WORKSHOP AGENDA

Planning Commission
June 16, 2026 @ 5:30 PM
For the June 30, 2026 Regular Meeting @ 6:00 PM

Planning Commission Report
Meeting: June 16, 2026

Item #: 3. **Site Plan - 1370 Heil Quaker Boulevard - Proposed Truck Parking on 2.51 Acres. Property located at 1370 Heil Quaker Blvd. (Tax Map 17, Parcel 28.01). ID (Interchange District) Zoning District. Property owned by Harsimranjeet Kaur. Requested by Huddleston Steele, Inc.**

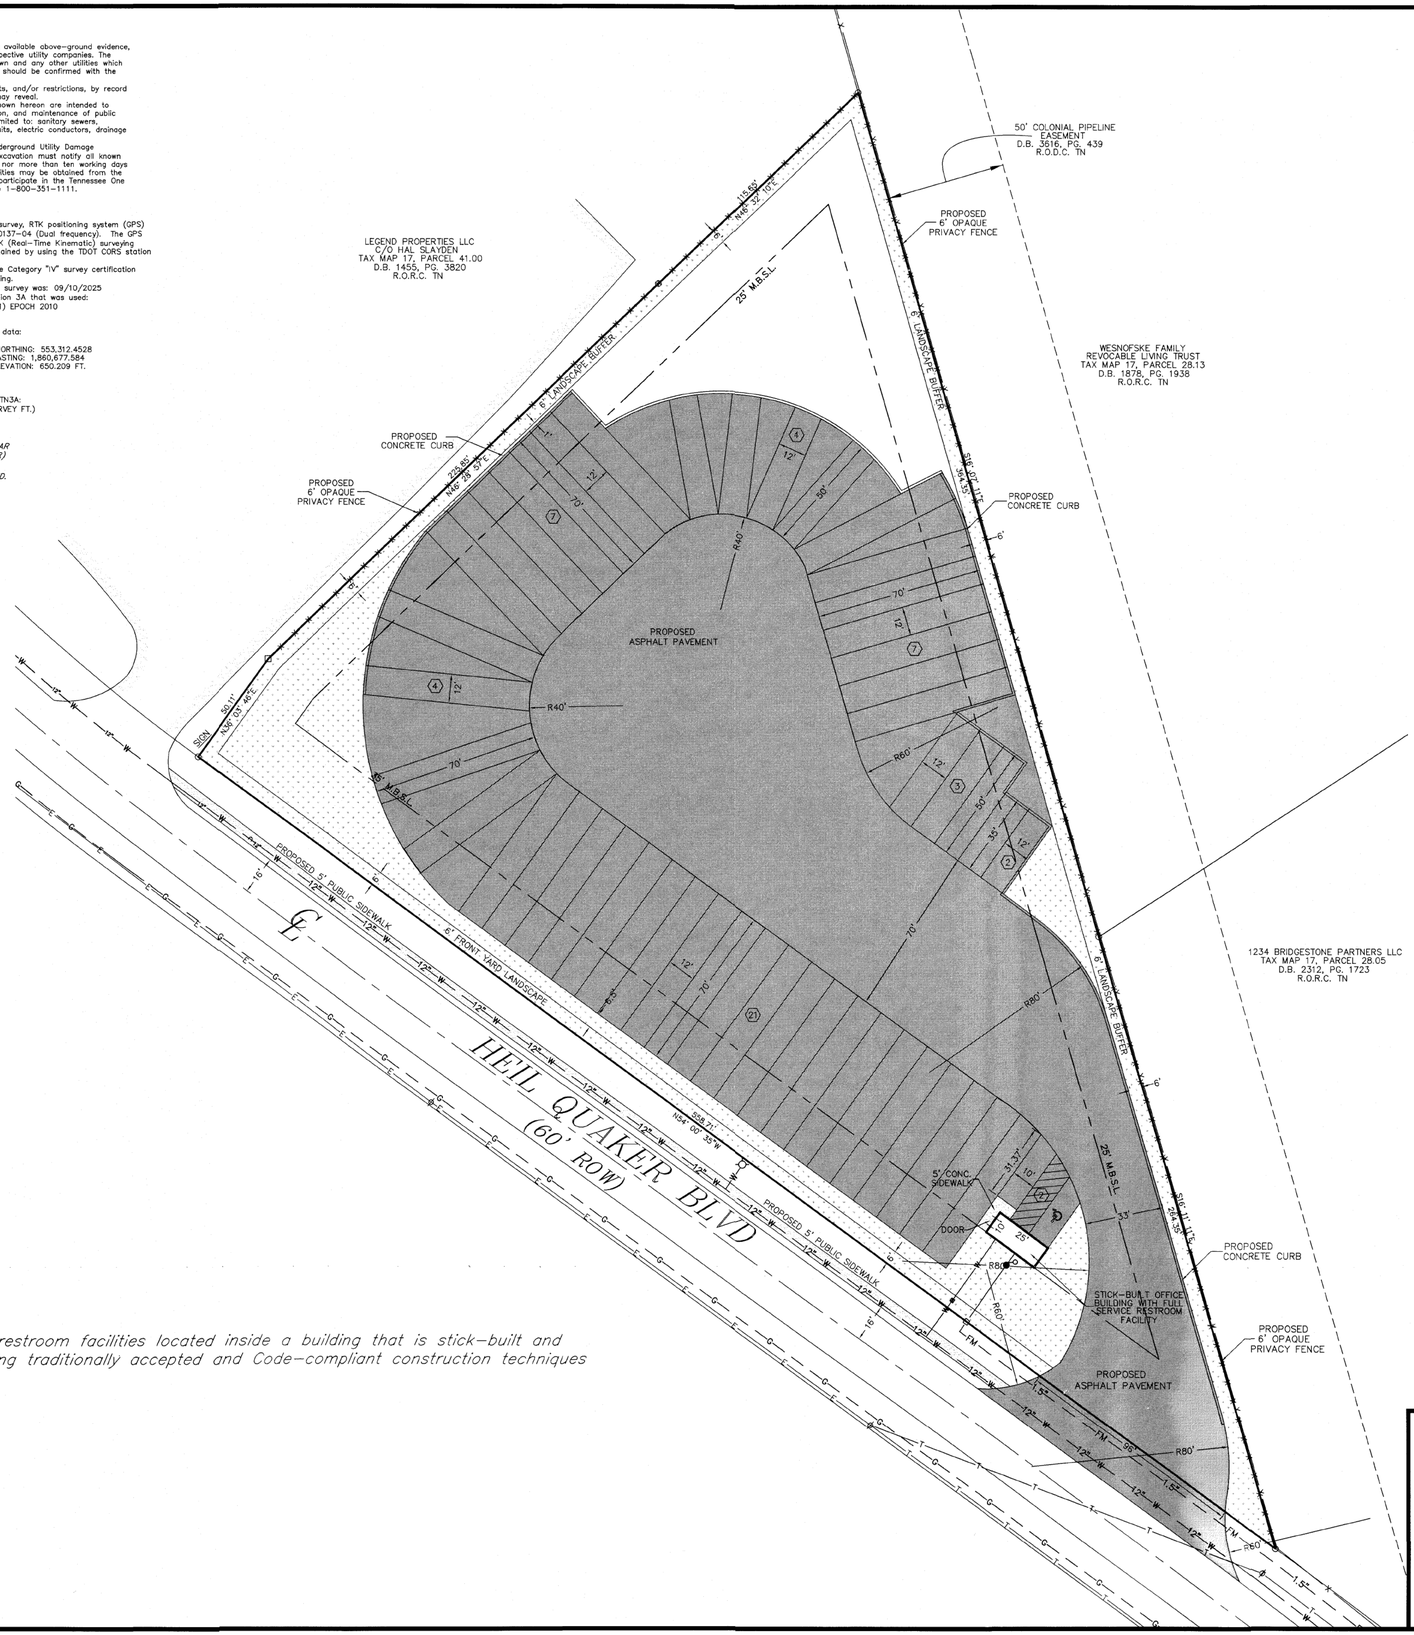
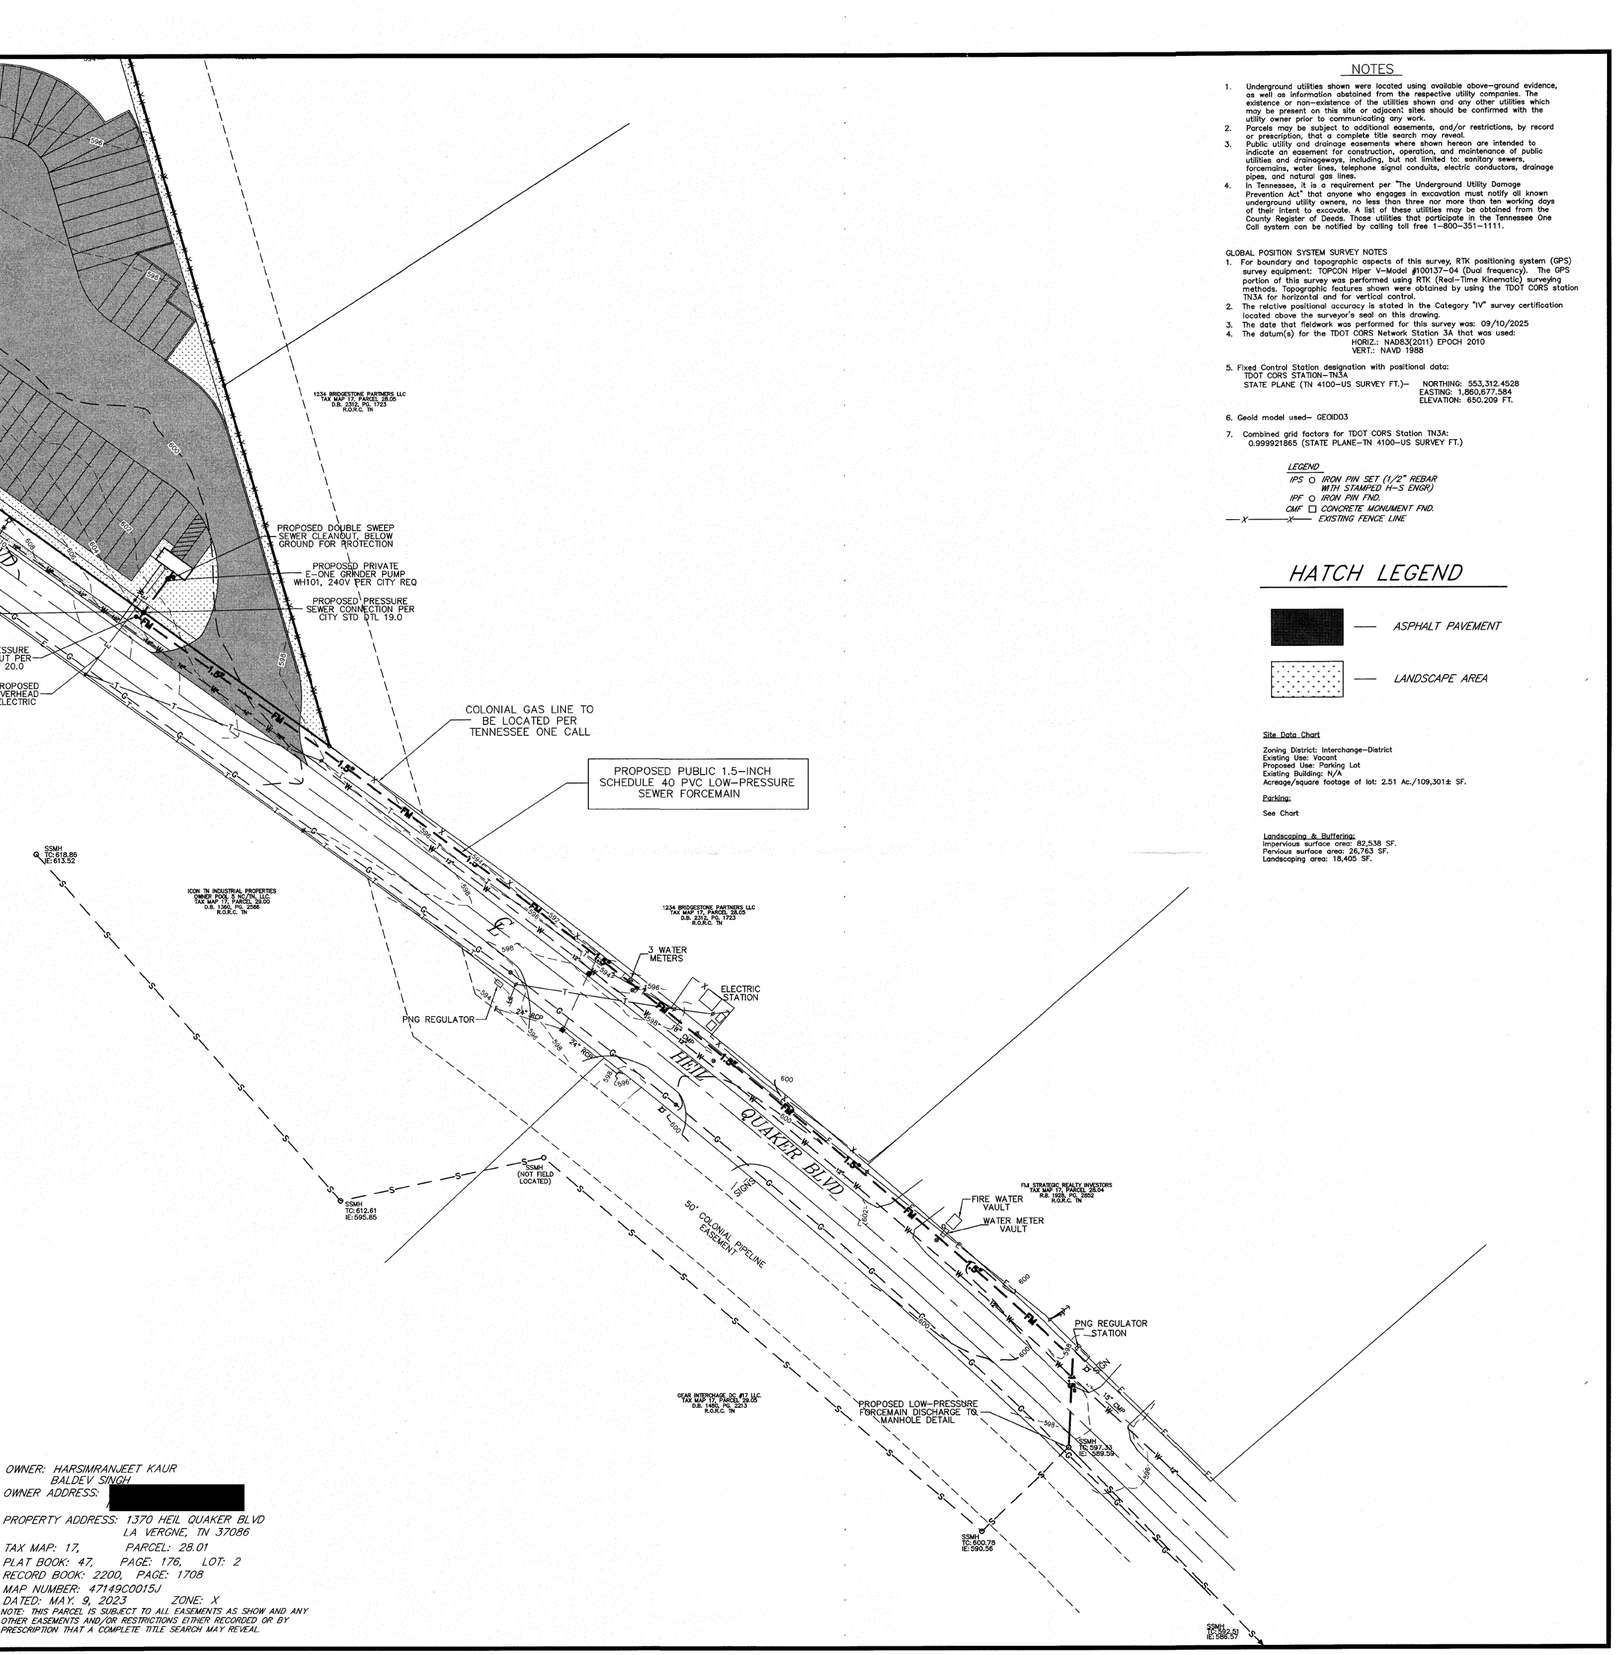
2. Near the southeast corner of 1370 Heil Quaker, the drawing shows a Telephone line "T" crossing Heil Quaker Blvd form north to south side of street on an oblique angle. That does not look like telephone, it looks like cable and should be labeled properly. Cable is lower on the pole and that is important information for the Contractor.

3. Where the 1.5-inch forcemain is aligned near a utility pole (several locations), show the alignment at least 3 feet off the utility pole using 45-degree bends, or 22.5-degree bends, and note the alignment change with this information, "*maintain at least 3 feet clearance from utility poles and where forcemain is within 10 feet of a waterline it shall be at least 18 inches below the bottom of the waterline.*" I see at least 4 locations where this note applies.

5. Show colonial Gas line on plans. Obtain information from gas company on existing gas line depth to determine if the sewer forcemain will cross over or under the gas.

SHEET NUMBER: C-2.0

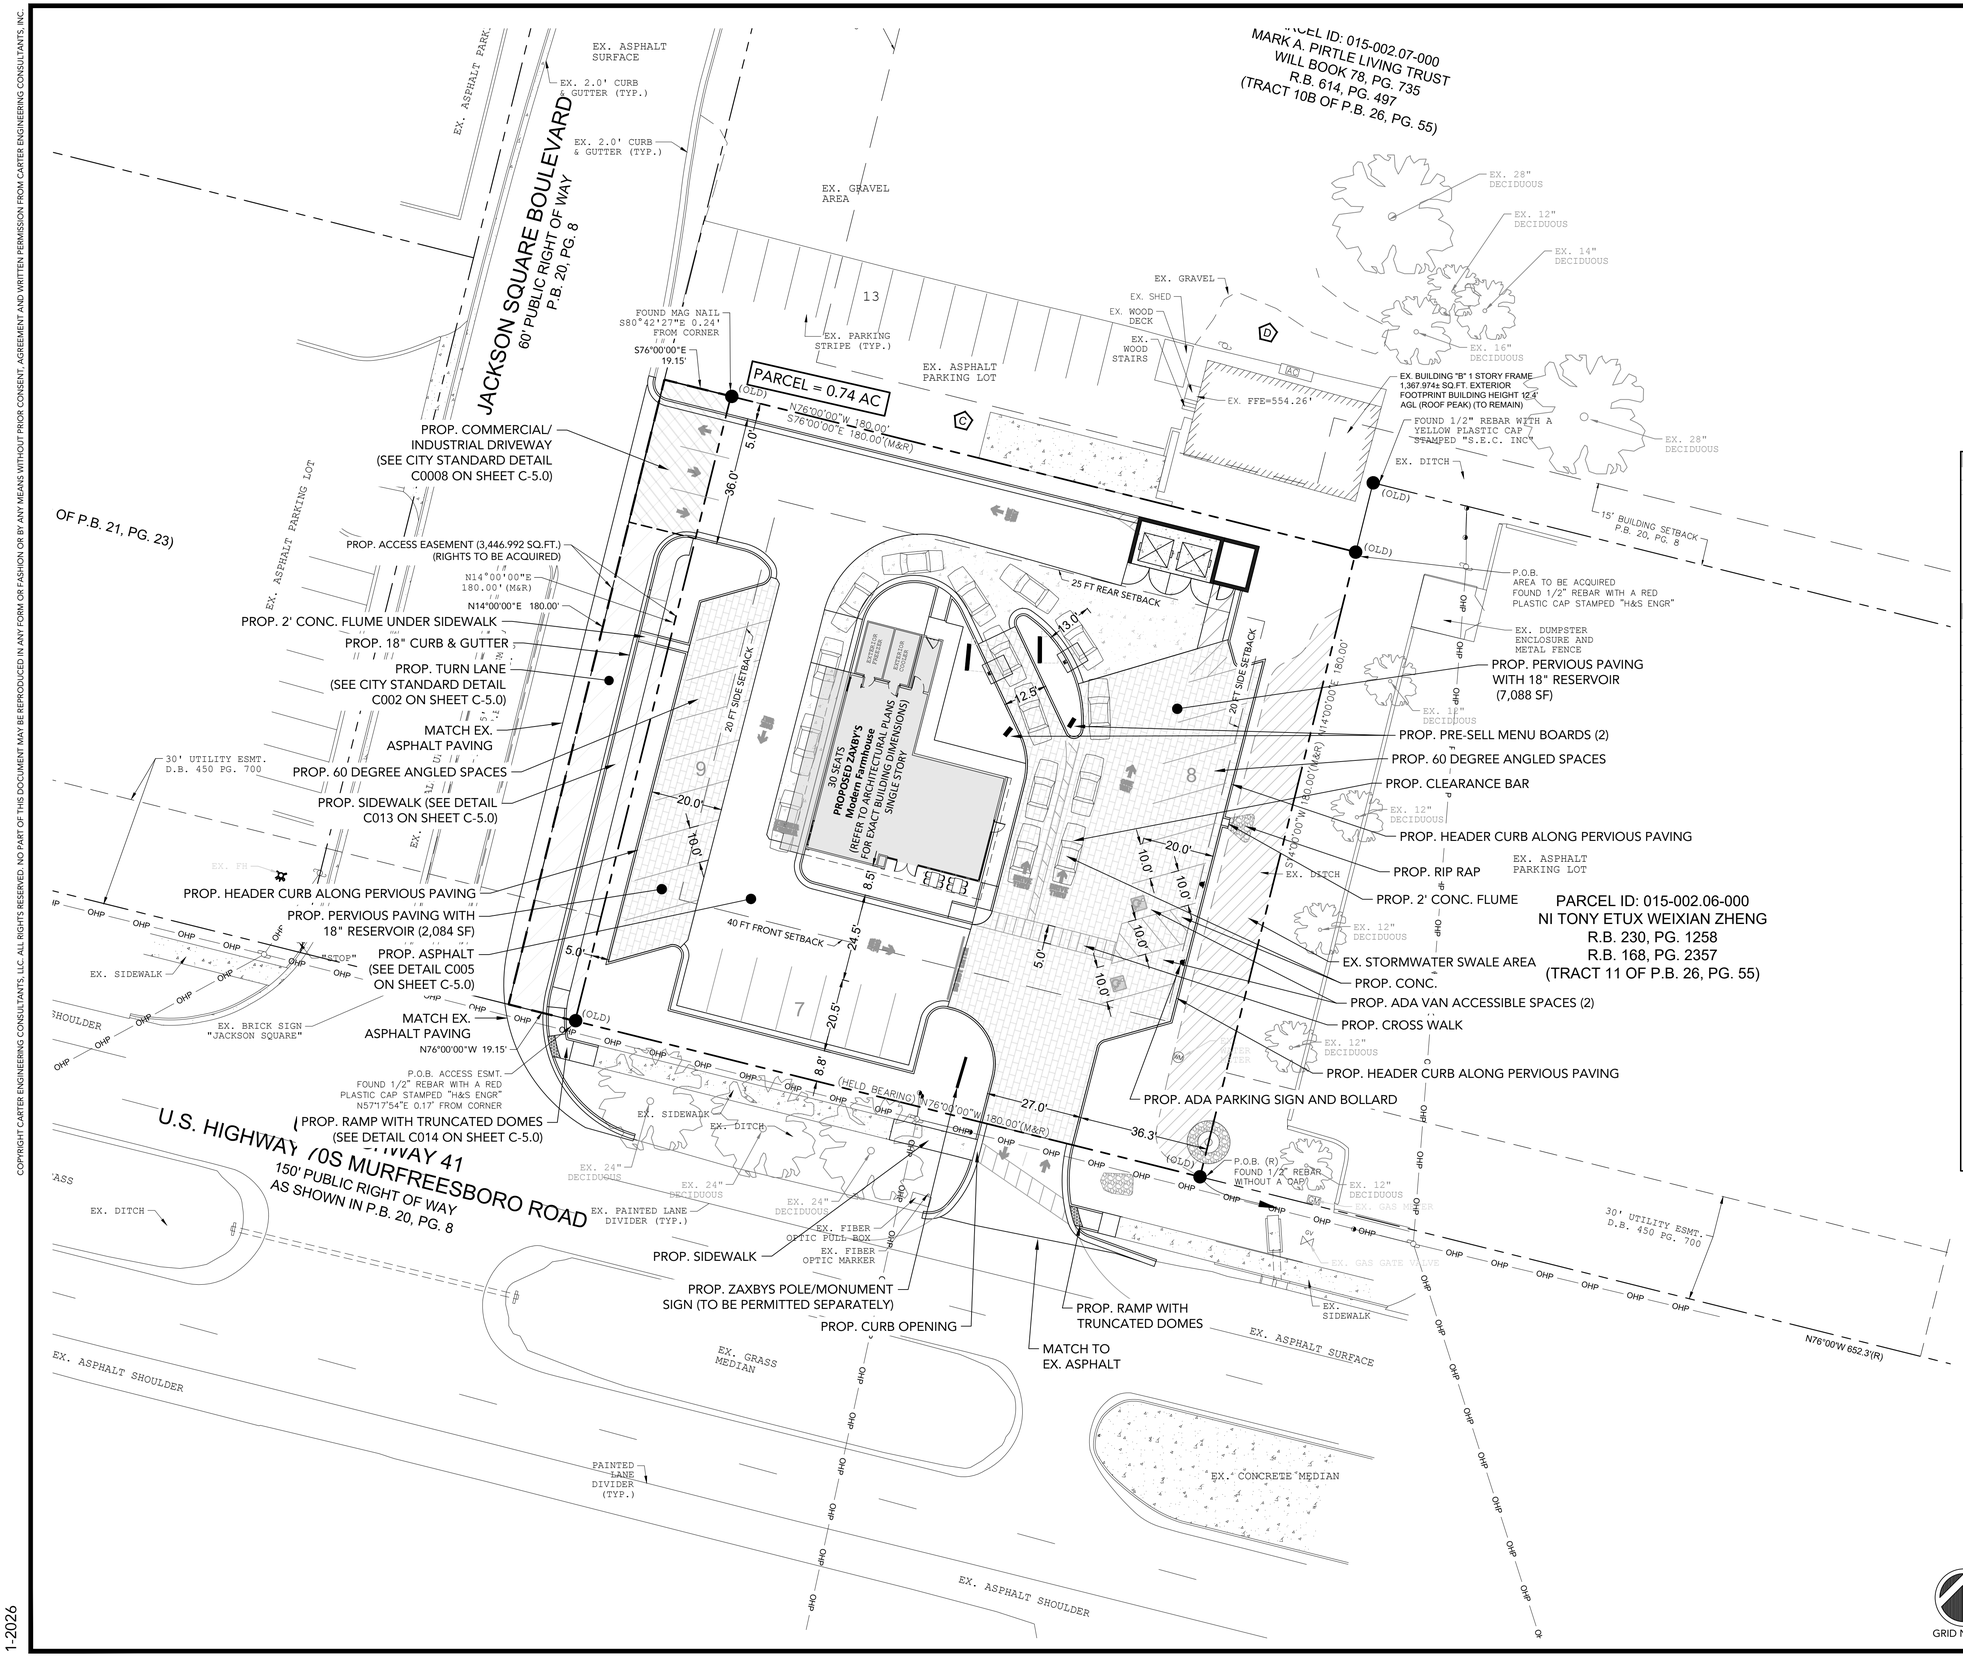
5. (Sheet C-2.0) Label curb and gutter along the widening of Jackson Square Blvd as 6" Post Curb & Gutter as per city detail C010 on sheet C-5.0
6. (Sheet C-2.0) While the monument/pole sign will be permitted separately through the Codes Department, provide the height, dimensions, and materials which will be used on that sign for review by the Planning Commission.

9. (For Planning Commission Information) The walls around the dumpster are split-face CMU.
10. (Sheet C-2.0) The square footage of the building appears to be incorrect. Please correct it.
